MegaCore IP Library Release Notes and Errata

MegaCore Library Version: 9.1
Document Version: 9.1.4
Document Date: 15 May 2010

Figure 4-1. Corrected CPRI MII Interface Transmitter Example

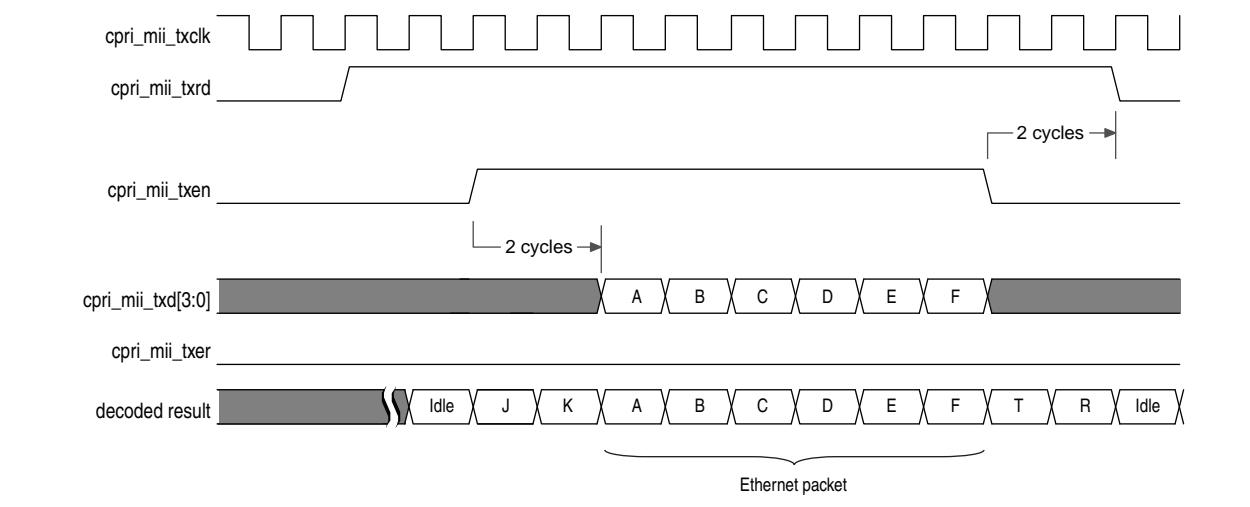
The CPRI MegaCore Function User Guide contains erroneous information about the MII interface. Figure 4-16 and Figure 4-17 in the CPRI MegaCore Function User Guide should be replaced with the figures in this erratum.

Typically, the external Ethernet block asserts `cpri_mii_txen` one clock cycle after `cpri_mii_txrd` is asserted. If not, in each clock cycle following that first cycle, while `cpri_mii_txrd` remains asserted but `cpri_mii_txen` is not yet asserted, the CPRI MII Interface transmitter inserts an Idle cycle in the buffer of data to be transmitted to the CPRI link. After `cpri_mii_txen` is asserted following the assertion of `cpri_mii_txrd`, if `cpri_mii_txen` is subsequently deasserted following a cycle in which `cpri_mii_txrd` remains asserted, the CPRI MII Interface transmitter assumes the external Ethernet block has reached end-of-frame, and begins insertion of the T and R nibbles.

Replace Figure 4-16 on page 56 of the CPRI MegaCore Function User Guide with the following [Figure 4-1](#).

Although [Figure 4-1](#) shows `cpri_mii_txrd` asserted continuously during transmission of an Ethernet packet on `cpri_mii_txd`, this is not always the case. The CPRI MII Interface transmitter can deassert `cpri_mii_txrd` while `cpri_mii_txen` is still asserted, to backpressure the external Ethernet block. If this happens, the Ethernet block must deassert `cpri_mii_txen` on the following cycle, to prevent the MII Interface transmitter buffer from overflowing. The `cpri_mii_txen` signal should remain deasserted until the cycle following reassertion of `cpri_mii_txrd`. If `cpri_mii_txen` is not reasserted in the cycle following the reassertion of `cpri_mii_txrd`, then an Idle cycle is inserted in the packet; therefore, the external Ethernet block must reassert `cpri_mii_txen` in the cycle following reassertion of `cpri_mii_txrd`.

Figure 4-2. Corrected CPRI MII Interface Receiver Example

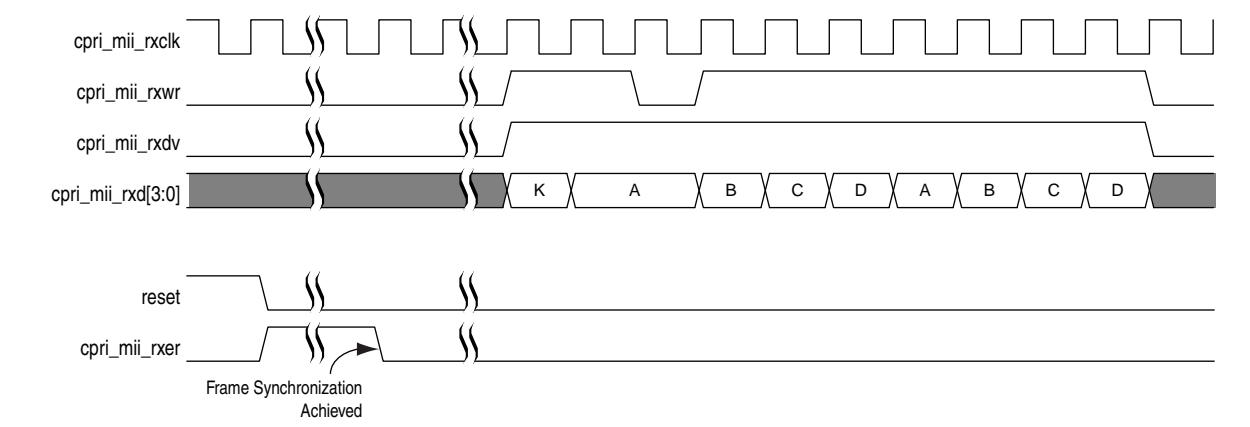
The CPRI MII Interface receiver transmits the K nibble to indicate start-of-frame on the MII interface. Replace Figure 4-17 on page 57 of the CPRI MegaCore Function User Guide with the following [Figure 4-2](#).

The J nibble of the start-of-frame is consumed by the CPRI MegaCore function, and is not transmitted on the MII interface.

The corrections indicated above apply to Figure 4-18 on page 57 of the CPRI MegaCore Function User Guide as well.

Figure 16-1. 128-Bit Avalon-ST rx_st_data0 Cycle Definition for 3-DWord Header TLPs with QWord Aligned Addresses

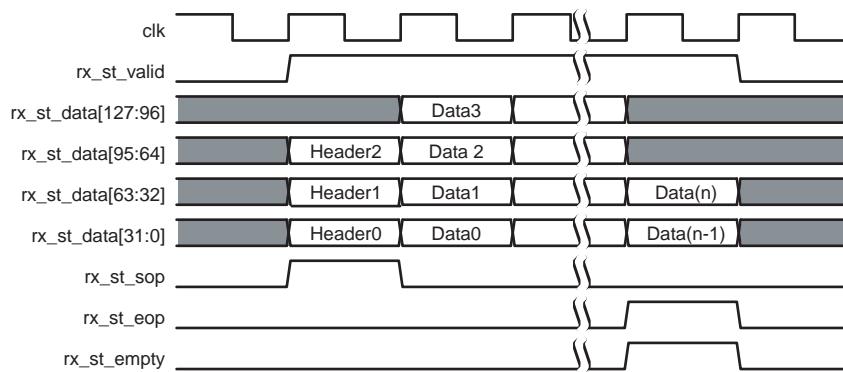
In 128-bit mode, the qwords in the timing diagrams are swapped. The correct order for Rx or Tx data[127:0] is {H3, H2, H1, H0}. The *PCI Express Compiler User Guide* shows data[127:0] as {H1, H0, H3, H2}. In addition, the rx_st_empty0 and tx_st_empty0 signals indicate that the TLP ends in the *lower* words of data. The corrected diagrams and text are given here.

Figure 16-1 shows the mapping of 128-bit Avalon-ST Rx packets to PCI Express TLPs for TLPs with a three dword header and qword aligned addresses.

Figure 16-2. 128-Bit Avalon-ST rx_st_data0 Cycle Definition for 3-DWord Header TLPs with non-QWord Aligned Addresses

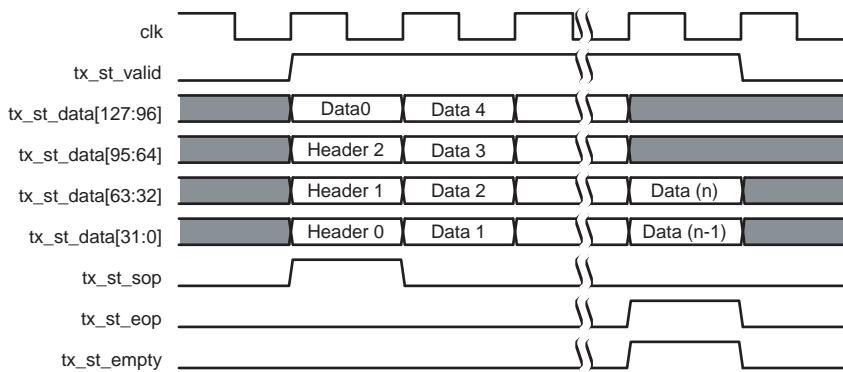
Figure 16-2 shows the mapping of 128-bit Avalon-ST Rx packets to PCI Express TLPs for TLPs with a 3 dword header and non-qword aligned addresses.

Figure 16-3. 128-Bit Avalon-ST rx_st Cycle Definition for 4-DWord Header TLPs with non-QWord Aligned Addresses

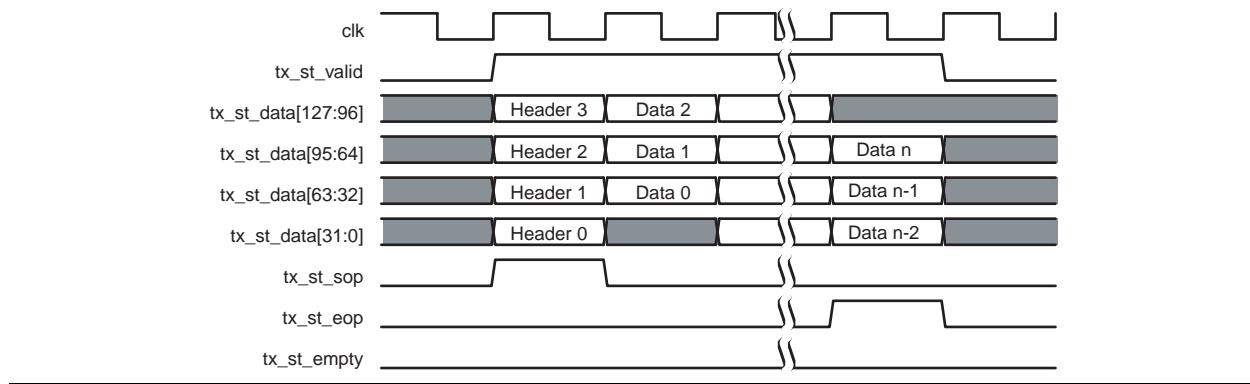
Figure 16-3 shows the mapping of 128-bit Avalon-ST Rx packets to PCI Express TLPs for a four dword header with non-qword aligned addresses. In this example, rx_st_empty is low because the data ends in the upper 64 bits of rx_st_data.

Figure 16-4. 128-Bit Avalon-ST rx_st Cycle Definition for 4-DWord Header TLPs with QWord Aligned Addresses

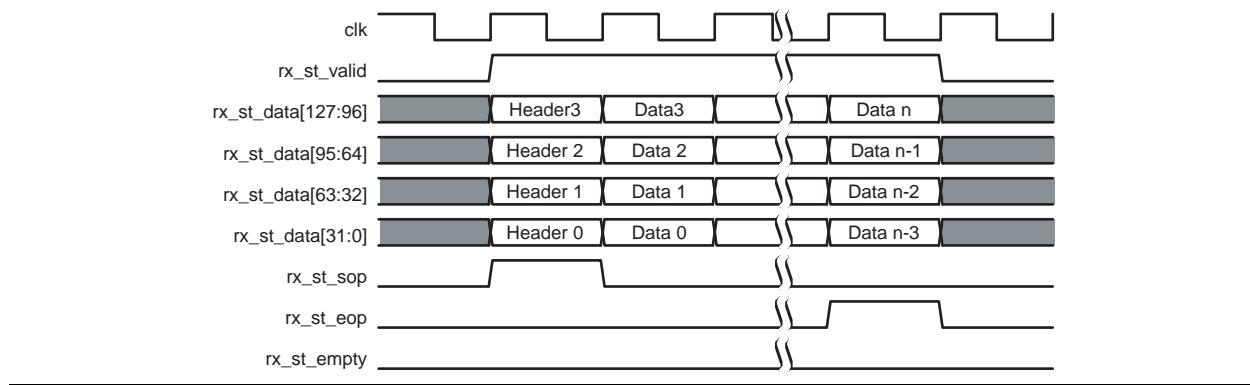
Figure 16-4 shows the mapping of 128-bit Avalon-ST Rx packets to PCI Express TLPs for a four dword header with qword aligned addresses.

Figure 16-5. 128-Bit Avalon-ST tx_st_data Cycle Definition for 3-DWord Header TLPs with QWord Aligned Addresses

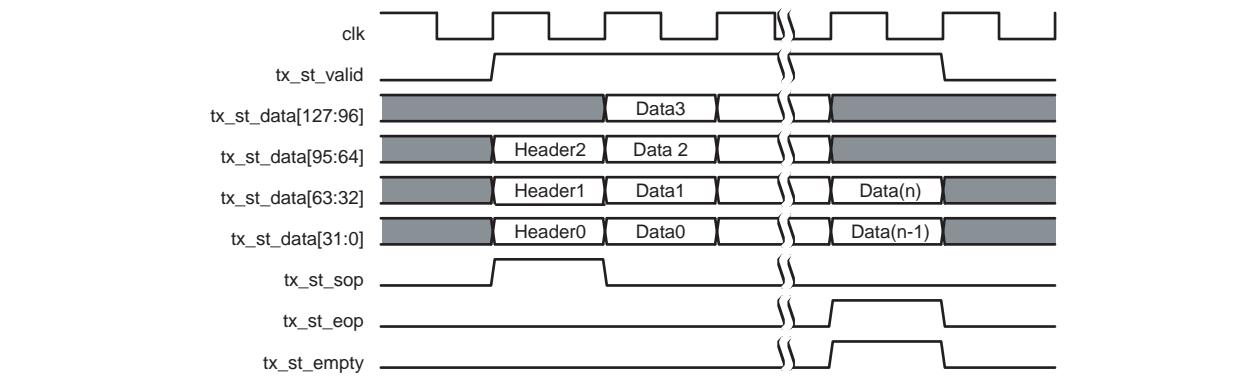
Figure 16-5 shows the mapping of 128-bit Avalon-ST Tx packets to PCI Express TLPs for a three dword header with qword aligned addresses.

Figure 16-6. 128-Bit Avalon-ST tx_st_data Cycle Definition for 3-DWord Header TLPs with non-QWord Aligned Addresses

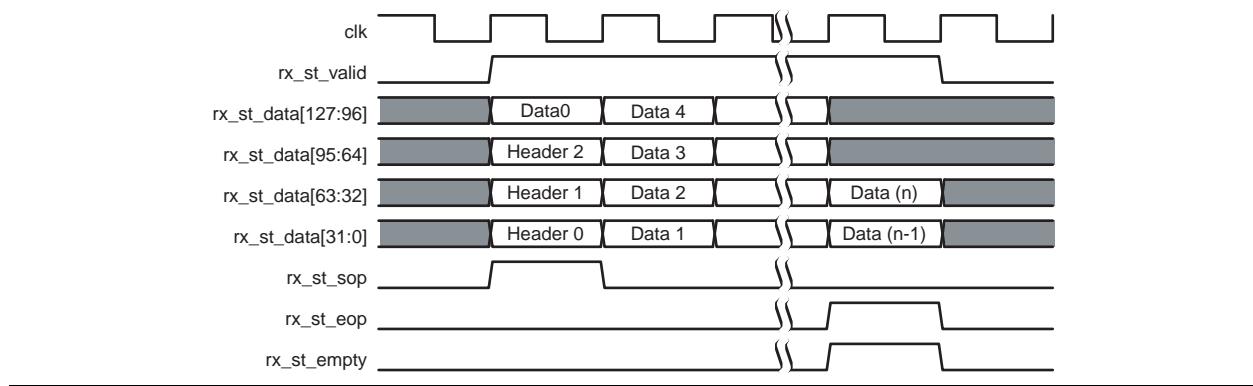
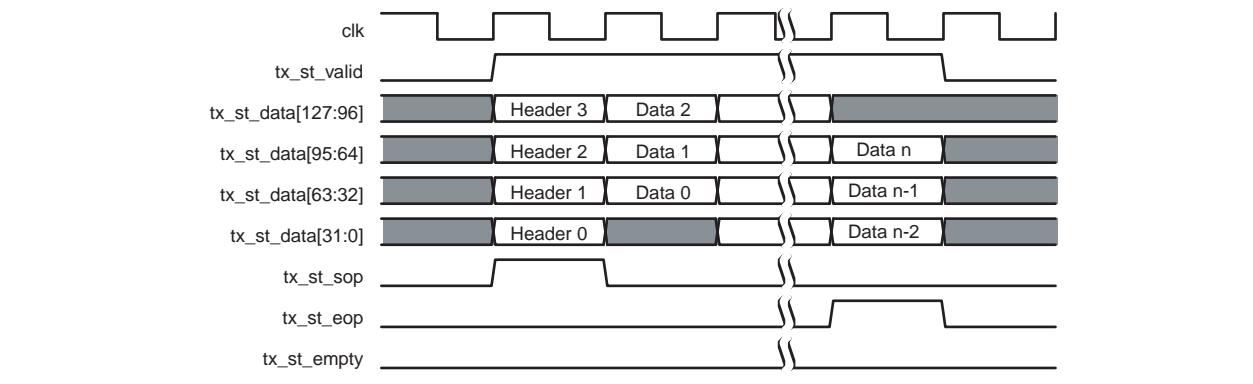
Figure 16-6 shows the mapping of 128-bit Avalon-ST Tx packets to PCI Express TLPs for a 3 dword header with non-qword aligned addresses.

Figure 18-1. DIP-4 Counter *(Note 1)***Note to Figure 18-1:**

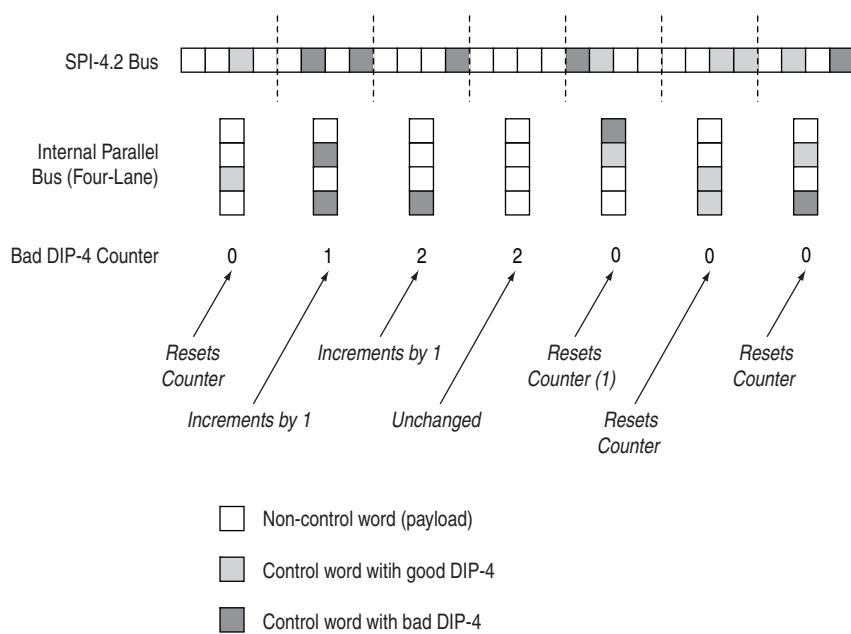
The following paragraph is correct:

If the `stat_rd_dip4_oos` signal is low, and all of the DIP-4s in the control words received in the current clock cycle (up to 8 in 128-bit mode) are errored, the bad counter is incremented by 1; otherwise it is reset to 0. If the bad counter reaches the `bad_level` threshold, the `stat_rd_dip4_oos` flag is asserted. A `bad_level` of 0 is invalid.

[Figure 18-1](#) shows an example of the DIP-4 counter, where the receiver is in service state and bad threshold is 3.

(1) Receiving a good and a bad DIP-4 in the same parallel cycle resets the counter (does not increment it), so that OOS does not trigger.
